Access Compliance Report

Public Rights-of-Way

(Curb Ramps)

Intersection ID: N/A	Main Street: SOLAR_WY	Cross Street: ROCK_ISLAND_RD	Location: NW
ADA ID: 7136F951CF97	Ramp Type: Perp	Initial Pass/Fail: Fail	Overall Compliance: No
Severity Score: 22.5			
Codes/Mitigation Info/Possible Solution		Field Measurements/Component Compliance

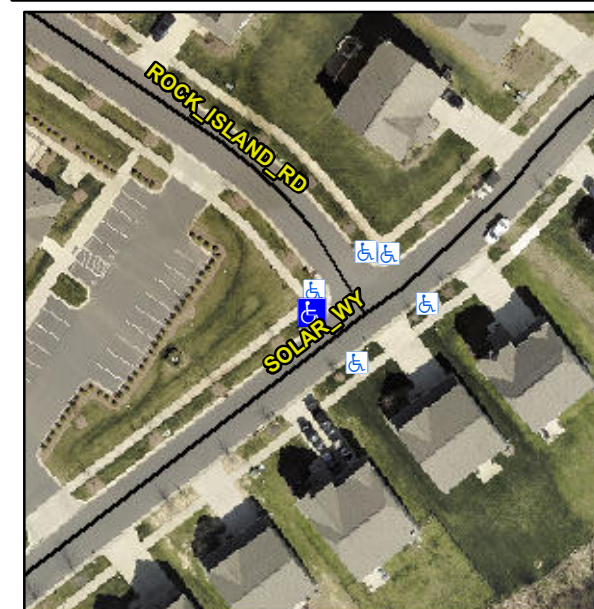
Not Found, R304.5.1, R304.2.2

Compliance	Description	Data	Compliance	Description	Data
N/A	Ramp Length (in)	105.0	No	Ramp Slope (%)	9.3
No	Ramp Width (in)	46.5	Yes	Ramp XSlope (%)	3.3
N/A	Flare Type LT	N/A	N/A	Flare Type RT	N/A
N/A	Flare Slope LT (%)	N/A	N/A	Flare Slope RT (%)	N/A
N/A	Flare Traversable LT?	N/A	N/A	Flare Traversable RT?	N/A
N/A	Landing Length (in)	N/A	N/A	DWS Provided?	N/A
N/A	Landing Width (in)	N/A	N/A	DWS Contrast?	N/A
N/A	Landing Slope (%)	N/A	N/A	DWS Length (in)	N/A
N/A	Landing X Slope (%)	N/A	N/A	DWS Full Width?	N/A
N/A	Landing Curb? (Y/N)	N/A	N/A	DWS Offset (in)	N/A
N/A	Shared Landing?	N/A			
N/A	Gutter Ponding?	N/A	N/A	Gutter Slope (%)	N/A
N/A	Gutter Lip Ht (in)	N/A	N/A	Gutter X Slope (%)	N/A
N/A	Painted X Walk1?	No	N/A	Painted X Walk2?	N/A
	X Walk 1 Direction	To SE		X Walk 2 Direction	N/A
N/A	X Walk 1 Width (in)	N/A	N/A	X Walk 2 Width (in)	N/A
	X Walk 1 Slope (%)	3.2		X Walk 2 Slope (%)	N/A
	X Walk 1 X Slope (%)	3.4		X Walk 2 X Slope (%)	N/A

Remove & Replace Entire Ramp.
